**BOARD OF ADJUSTMENT MEETING
CITY OF ST. PETE BEACH**

Wednesday, November 30, 2022
2:00 PM

CITY OF ST. PETE BEACH
DRAFT BOARD OF ADJUSTMENT MEETING MINUTES
October 26, 2022 2:00 P.M.

Date: September 13, 2022
To: Board of Adjustment
Re: Variance Case No: 22051
Practical Difficulty Variance
Address: 1020 Boca Ciega Isle Dr.
Parcel Number: #06-32-16-09594-001-0450
Lauren Rubenstein, Esq. for Donald and Mary Shamblin, Owner
Prepared by: Kristin Coman, Senior Planner

Figure 5: Survey with elevated mini split unit locations (N.T.S.)

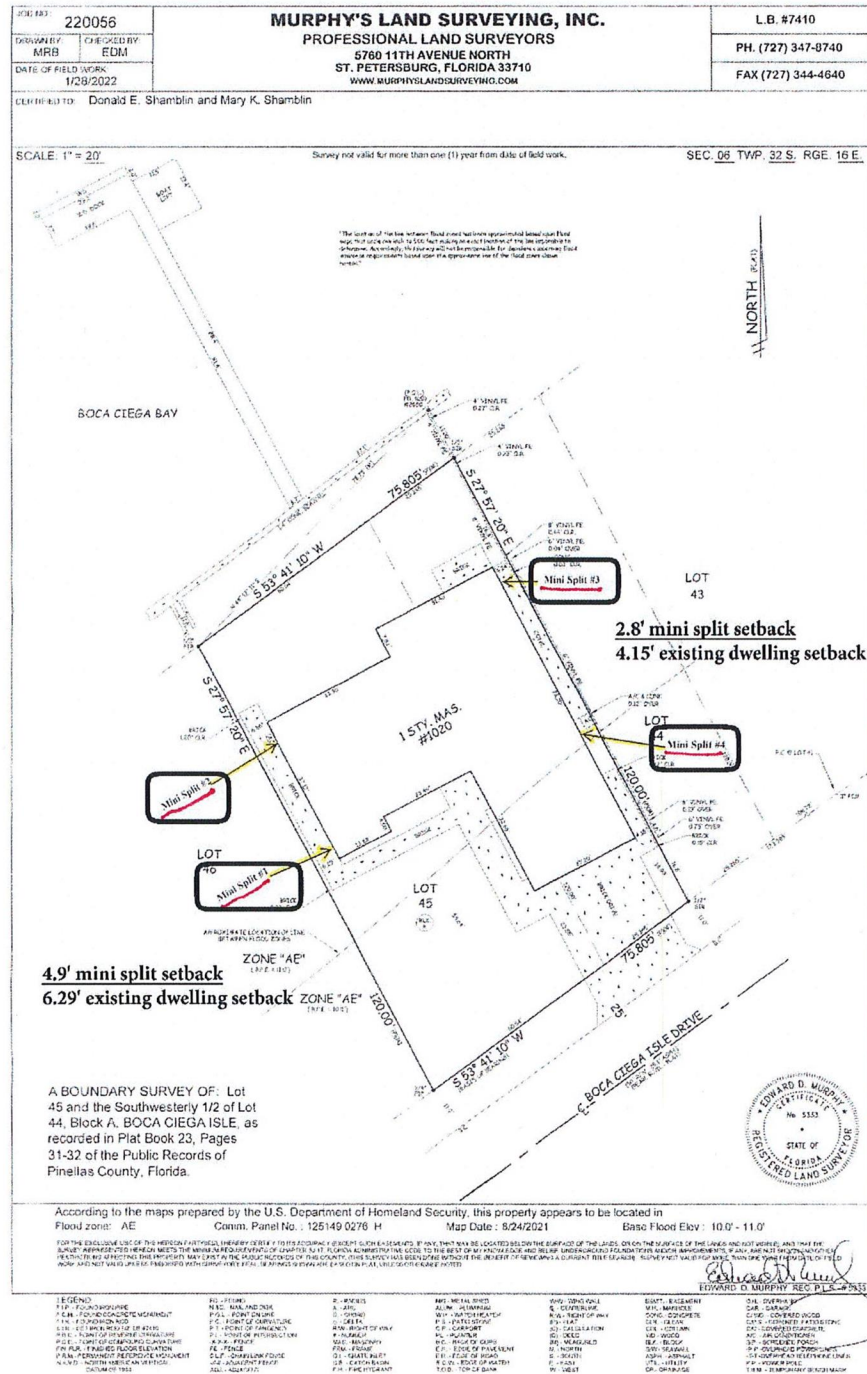
It should be noted that Sec. 6.14 of the Land Development Code specifically addresses the encroachment of certain specified ancillary residential equipment into required yards where equipment that is not at grade shall not encroach into any required front or side yard setback.

The Applicant should provide testimony regarding the necessity for the requested variances.

Staff finds no adverse change will be produced in the character of the neighborhood. The locations of the elevated mini splits are located such that they are not visible from the front yard of the property and are screened from both adjoining neighbors due to current landscaping and existing fencing.

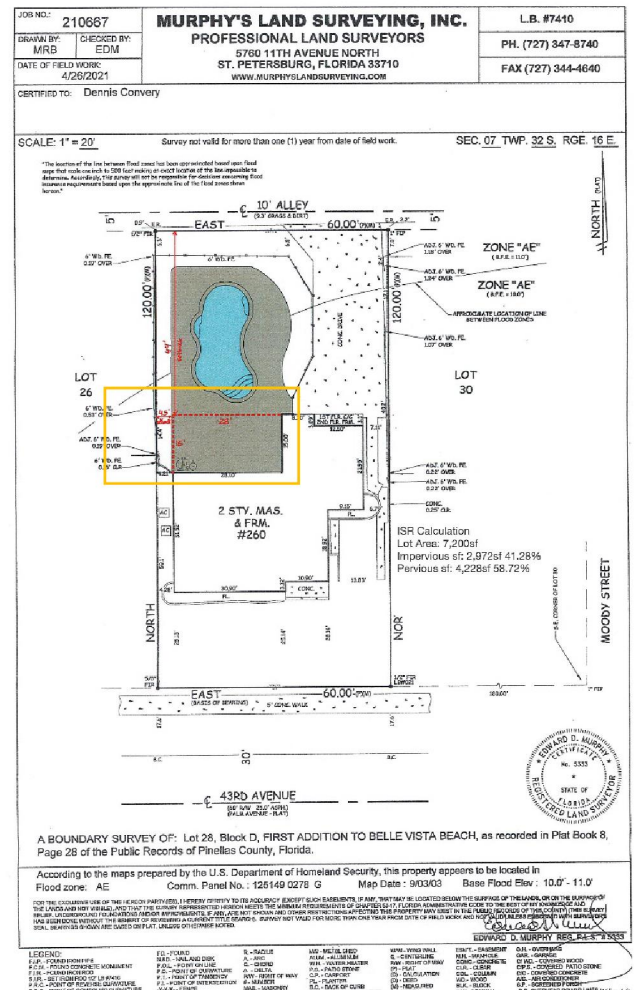
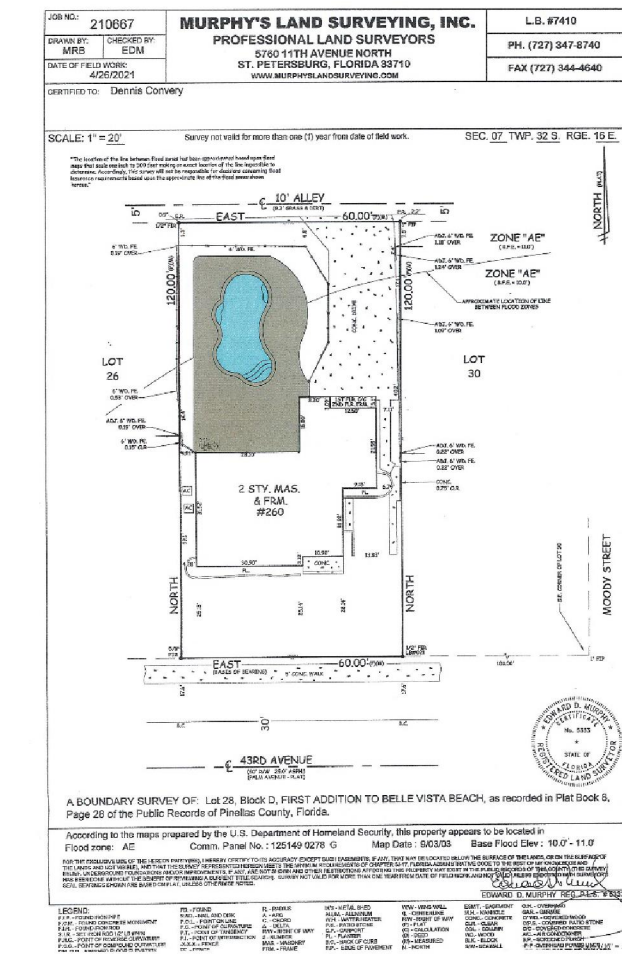
The Applicant should provide testimony regarding the necessity for the requested variances.

Staff finds that no adverse change will be produced in the character of the neighborhood. The proposed patio cover is located within the rear yard and attached to the home. Existing 6' high fencing aids in screening the adjacent properties, including those to the side and rear.

The additions could be revised to meet the required side yard setback without the need to receive a side setback variance. Staff understands the proposed patio cover is to be located on top of the newly constructed rear patio containing a pool which would allow for coverage over an existing seating area. However, the applicant has advised that due to existing piping located under the existing patio which serves the pool a change in dimension would interfere with the anchoring of the proposed patio.

- Construction drawings submitted show the sides of the structure to be open. Applicant should confirm and advise if there are any plans to enclose the structure. It should be noted that Sec. 6.13(c)(3) of the LDC does not permit the structure to be enclosed to be construed as living space.
- The building plans indicate the patio cover is to be connected to the dwelling by fascia mount. The dwelling currently has gutters and leaders, and information should be provided how the applicant and/or homeowner should provide testimony as to how the stormwater runoff shall be directed and maintained on the property to ensure compliance with LDC Sec. 6.13(b)(3).

Figure 5: Proposed Site Plan

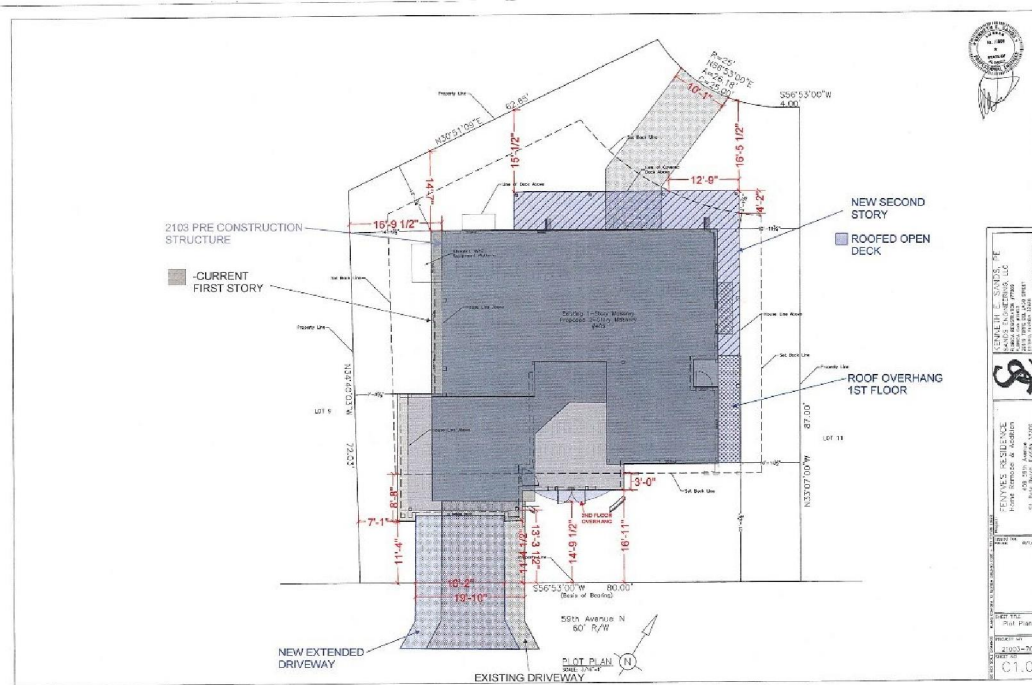
Additional Comments
